I am writing to comment on the request for Amendment #4 to the site certificate for the Summit Ridge Wind Farm. Even though the construction deadlines for this project have already been extended twice, the developer (Pattern Development) now seeks yet another extension. I urge EFSC to deny Pattern's request to extend the deadlines a third time.

I am writing to comment on the request for Amendment #4 to the site certificate for the Summit Ridge Wind Farm.

HABITAT MITIGATION PLAN

Figure 1. *Breeding pairs of burrowing owls among 46 plots in the APWRA from 2012 through 2016 as functions of breeding pairs in 2011 (Smallwood, unpublished data).*

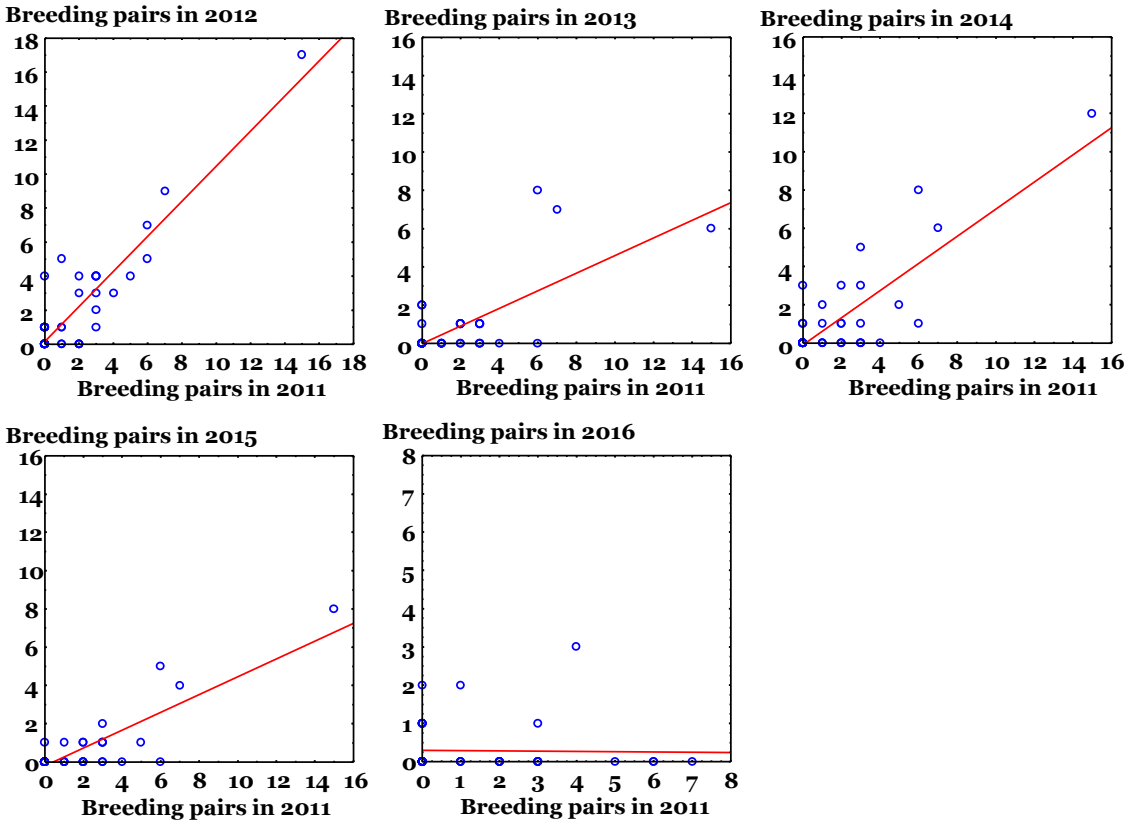
In fact, even without a major change in vegetation cover, wildlife typically shift activity areas every generation or so, as reported for >130 animal species worldwide (Taylor and Taylor 1979) and as found in my own research (Smallwood 2016, Smallwood and Morrison 2018, Smallwood unpublished data). In the Altamont Pass, for example, I began monitoring burrowing owls among 46 large sampling plots in 2011 (Smallwood et al. 2013), and have since found that I cannot predict the burrowing owl distribution several years following any given year (Figure 1; data from 2017 and 2018 further confirm the loss of predictability, but are not shown in this figure). Whereas I obtained a strong correlation between the number of breeding pairs per sampling plot in 2012 relative to the number of breeding pairs in those same plots in 2011, my correlation visibly declines with each succeeding year until the 2016 distribution bears no resemblance to the 2011 distribution, as indicated by the regression slope of 0 in Figure 1. Hypothesized causes for this shifting mosaic pattern of abundance include (1) escape from parasite loads, (2) escape from predator loads, (3) accumulating around more abundant food supplies while allowing food replenishment at vacated sites, (4) natural accumulation of dispersing young while adults in the natal area senesce, or (5) some combination of these causes. Whatever the cause, it is mistaken to regard wildlife distributions as static or habitat as spatially fixed.

Figure 2. *Golden eagle use rates at 19 APWRA wind projects regressed (red line) on use rates measured the year before and compared to slope of equivalency (dashed line) and 90% prediction interval calculated from hypothetical 2010 use rates differing 10% from 2009 use rates.*

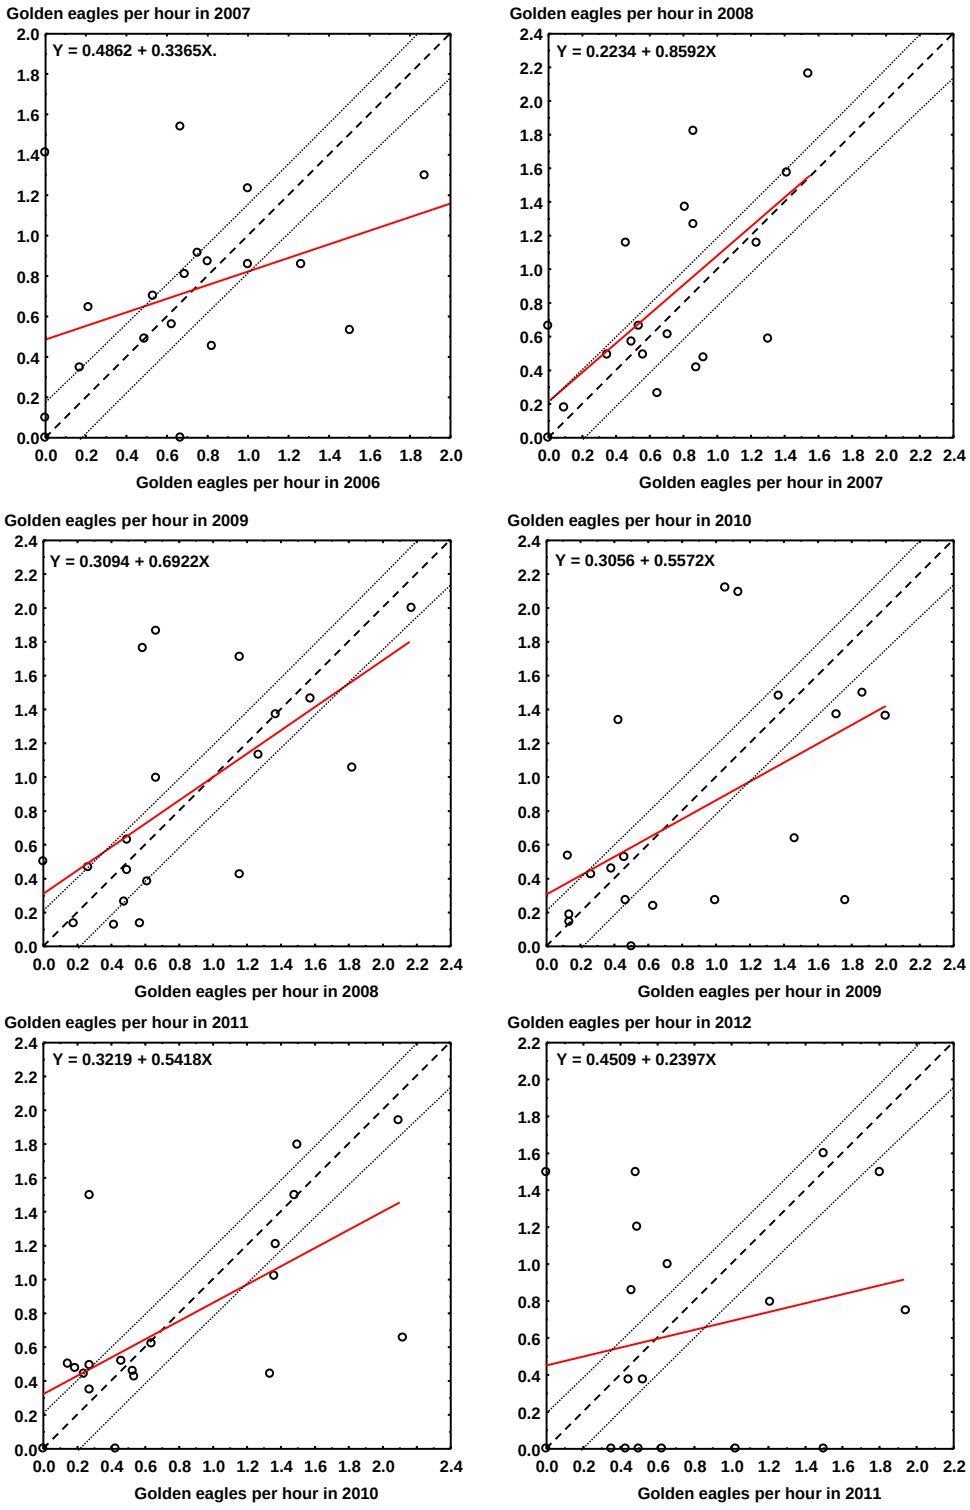
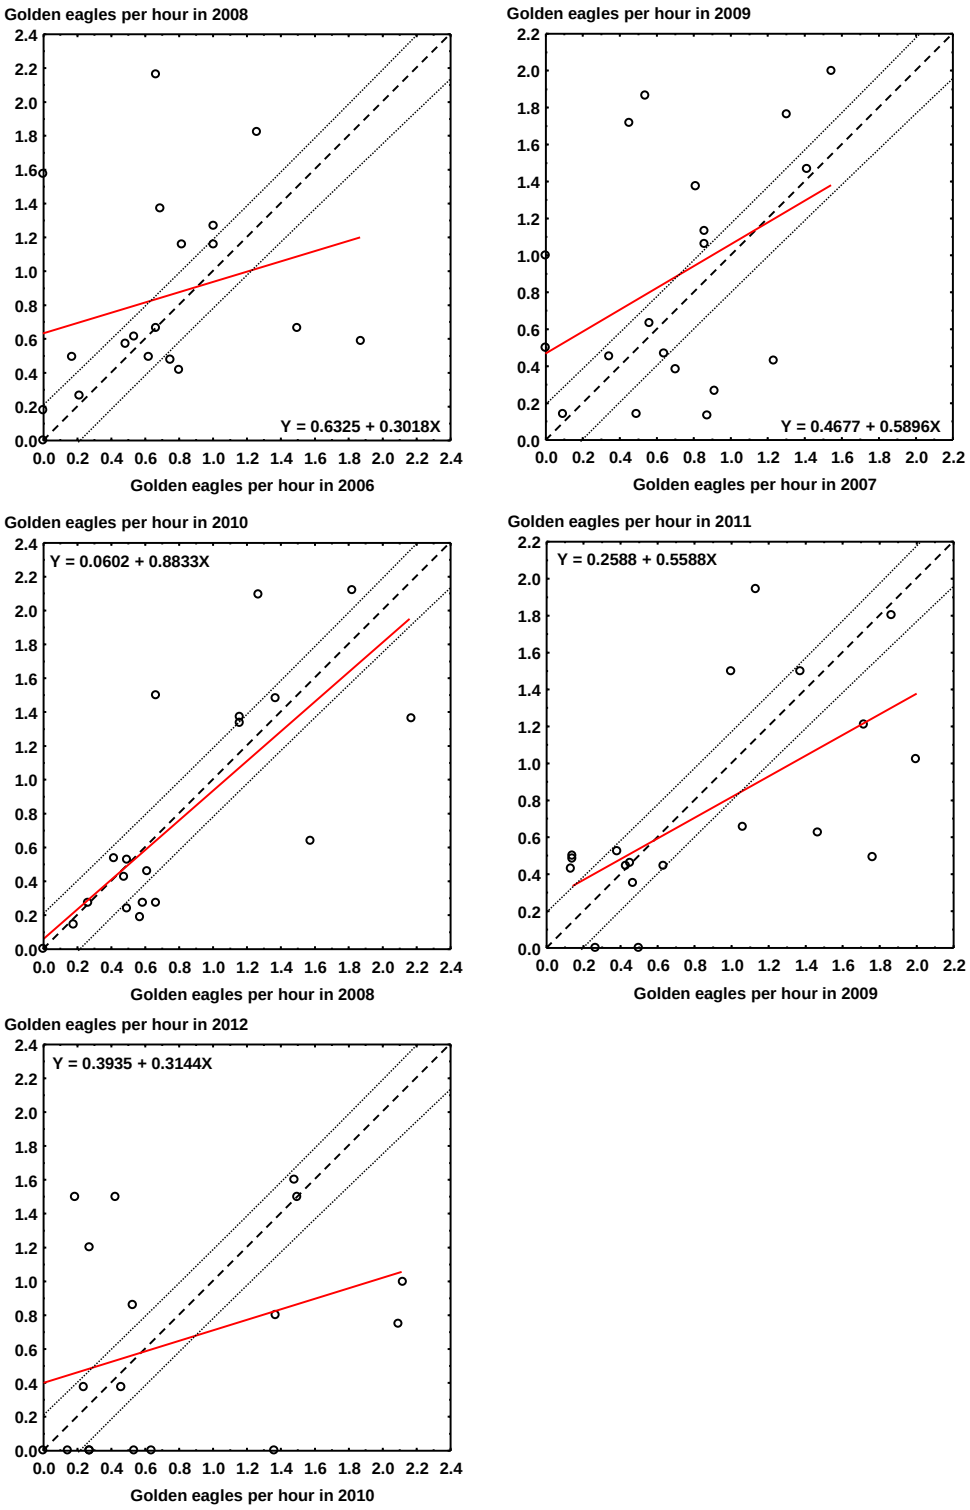
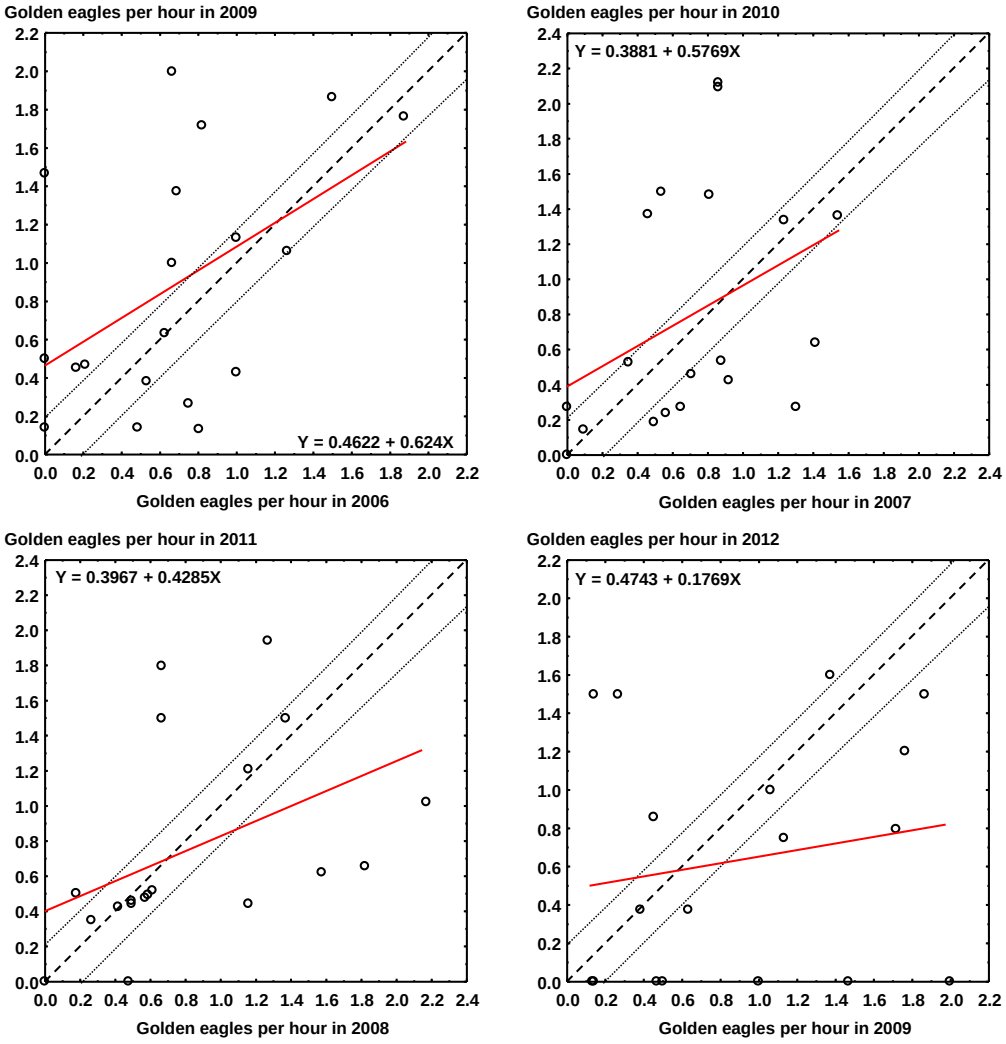
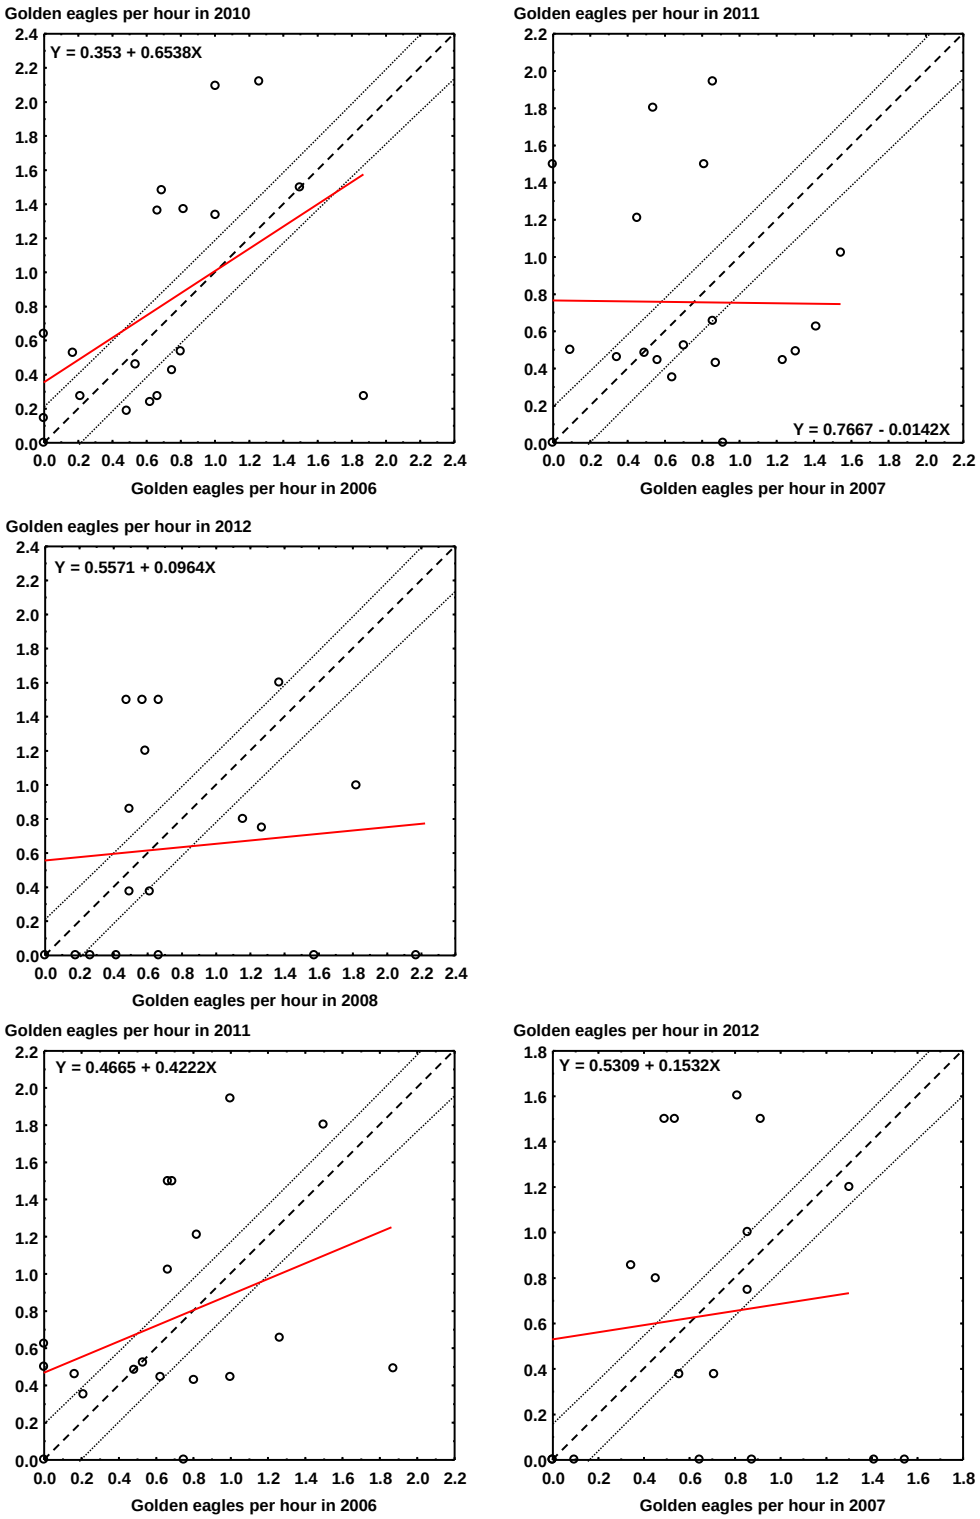
I tried the comparison using golden eagle use survey data from multiple years in the APWRA. One year's use rates predicted subsequent use rates with decreasing accuracy as the number of years separating the use rates increased (Table 1). With one year difference between use rates, the linear regression slope differed significantly from 0 in 4 of 6 years, but r^2 averaged only 0.34 among the 4 years with slopes >0 and root-mean square error (RMSE) averaged 0.48 and the proportion of use rates included within the 90% prediction intervals averaged only 45% of the 19 stations (Table 1, Figure 2). With two years difference between use rates, the linear regression slope differed significantly from 0 in 2 of 5 comparisons, but r^2 averaged only 0.46 between the 2 years with slopes >0 and RMSE averaged 0.45 and the proportion of use rates included within the 90% prediction intervals averaged only 42% of the 19 stations (Table 1, Figure 3). With three years difference between use rates, the linear regression slope differed significantly from 0 in 1 of 4 comparisons, but r^2 was only 0.19 for the comparison with slope >0 and RMSE was 0.45 and the proportion of use rates included within the 90% prediction intervals was only 32% of the 19 stations (Table 1, Figure 4). With four years difference between use rates, the linear regression slope differed significantly from 0 in 1 of 3 comparisons, but r^2 was only 0.19 for this comparison with slope >0 and RMSE was 0.46 and the proportion of use rates included within the 90% prediction intervals was only 26% of the 19 stations (Table 1, Figure 5). With five years difference between use rates, the linear regression slope differed significantly from 0 in neither comparison (Table 1, Figure 5). Even among comparisons for which regression slopes differed significantly from 0, the relationship in golden eagle use rates between years was weak. The relationship further weakened with the number of years between use rates. As was clear for burrowing owls (Figure 1), golden eagle use rates measured over one year in one place cannot be relied upon to predict golden eagle use 3 years hence.

As earlier illustrated in Figures 1 through 5, use rates shift spatially and inter-annually, so use rates estimated in one year cannot be expected to represent use rates 14 years hence. As an example of how things change, bald eagles – a species protected under the federal Bald and Golden Eagle Protection Act and the Migratory Bird Treaty Act – were not expected by the Alameda County Scientific Review Committee to be at risk of wind turbine collision in the Altamont Pass because use surveys rarely reported bald eagles in the Altamont Pass through 2011. Since 2011, however, bald eagles have been seen in increasing numbers. Last week I saw 3 bald eagles in 2 days in the Altamont Pass. A few years ago I found one dead under a wind turbine. Tetra Tech (2018:36) expects that Summit Ridge will not affect bald eagles, but I suggest that appropriate surveys might lead to an altered expectation. (Tetra Tech also claims in their Table 2 that bald eagles eat carrion in the upland environment, but in my experience they also catch and consume live prey just as golden eagles do.)

The use rates I compared in Figure 2 had been adjusted because we learned since 2010 that use rates are functions of maximum survey radius and they vary according to the proportion of the sky that is visible from any given observation station (Figure 9). As field biologists are asked to survey to greater distances, they miss increasingly larger proportions of the available birds, more so for small-bodied bird species than large-bodied species. As illustrated in Figure 9, these functions are biases if they are not quantified and accounted for in the use-rate metric (Smallwood and Neher 2017, Smallwood 2018). In Figure 9, the highest golden eagle use rates adjusted for occluding terrain were 11 times higher than without the adjustment. Without accounting for these biases, use-rate comparisons are potentially misleading, both between projects and within a project area when using the data to carefully micro-site the turbine layout with the intention of minimizing collision impacts.

***Figure 7**. Cumulative bat species detected in acoustic surveys increased with detector-nights per detection, based on 1,425 detector-nights at Vasco Winds Energy Project, 2010-11 (Normandeau 2011) and 2012-14 (Brown et al. 2016).*

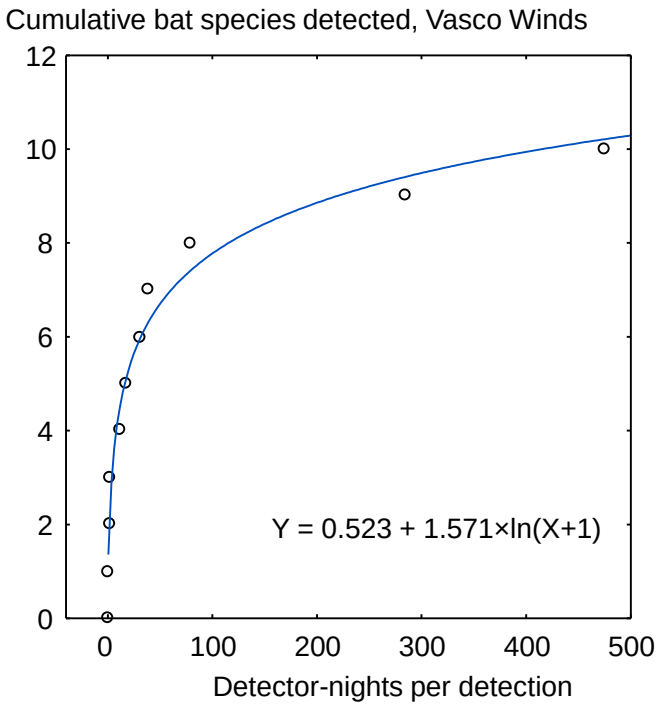
Based on the average detector-nights per detection of species (Figure 7), had Brown et al. (2016) relied solely on 16 detector-nights, we would have failed to detect 83% of the species that we actually detected. According to the model that best fits the data in Figure 7, we should have detected 12 species of bats after the 1,425 detector-nights used in the studies, so we likely missed two species. Assuming this model would be applicable to Summit Ridge, 16 detector-nights should have detected 2 or 3 species of the 15 or so potentially present, but Northwest Wildlife Consultants detected 7 species, or more than predicted. A possible explanation for the more-than-predicted detections was Northwest Wildlife Consultants' (2010) selection of study locations thought more likely to be used by bats, whereas the studies at my project site location were selected based on met tower availability or wind turbine sites. Nevertheless, Northwest Wildlife Consultants did not truly inventory bat species at Summit Ridge, nor did they identify bat species or quantify their activity levels within the airspaces likely to be swept by wind turbines. A survey effort is needed in the airspaces that will be affected by wind turbines.

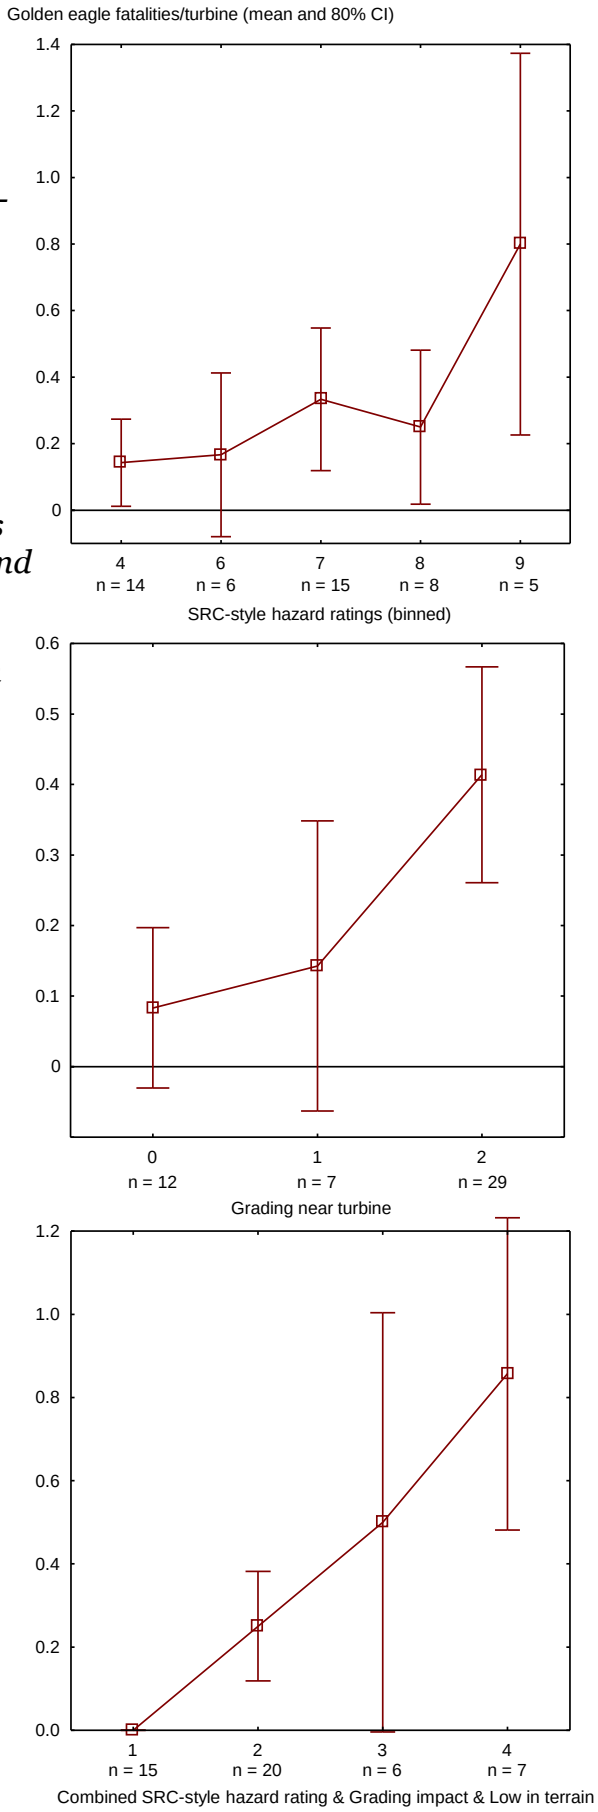
Figure 13 shows how golden eagle fatality rates varied among 48 modern wind turbines rated for landscape contributions to collision threat based on expert opinion (SRC-style ratings), levels of grading for the turbine pad and access roads, and a combination of expert opinion about the landscape setting and degree of grading. An emerging issue is the contribution of grading for turbine pad and access roads to subsequent wind turbine collision risk. Pads cut deeply into slopes can leave berms in the prevailing upwind aspect of turbine rotors, effectively reducing the space between the low-reach of the blades and the height above ground a bird needs to clear above the berm (Figure 14). This grading can also increase turbulence that birds or bats will experience as they fly from air above matrix slope conditions to air above a graded pad (Attachment 3). Wind speeds over such pads can drop radically, and wind directions can change. In addition to micro-siting to minimize collision risk, micro-siting to minimize grading should be an objective.

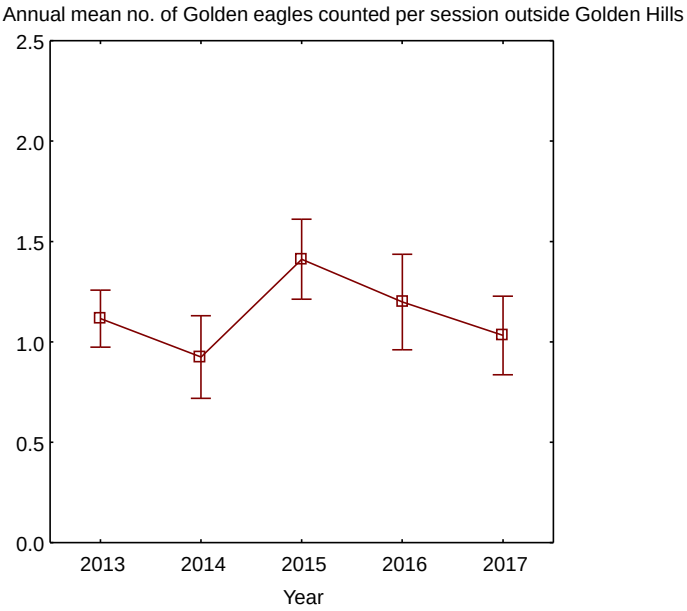
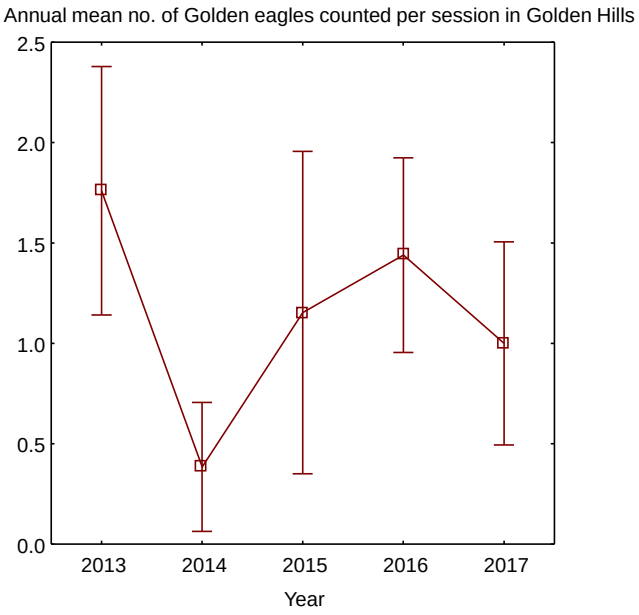
Based on the patterns in Figures 1 and 2, it does not appear that golden eagles were any more abundant during the first year of Golden Hills fatality monitoring than during the few preceding years, although they were 46% more abundant that during 2006-2011 (Smallwood and Neher 2017b). Regardless, without an experimental design, there is no way to know whether the number of collision fatalities would have been any different had the wind turbines been sited without regard to collision hazard posed by the terrain. Based on fatality rates preceding repowering (Smallwood and Neher 2017b), it is likely that the number of fatalities would have been higher in the absence of micro-siting. After all, estimates of golden eagle fatalities at the old-generation wind turbines replaced by Golden Hills (same project area and same rated capacity) numbered 17 and 19 in 2006 and 2007 (Smallwood and Neher 2017b), or nearly twice the estimated post-repowering number in 2017.
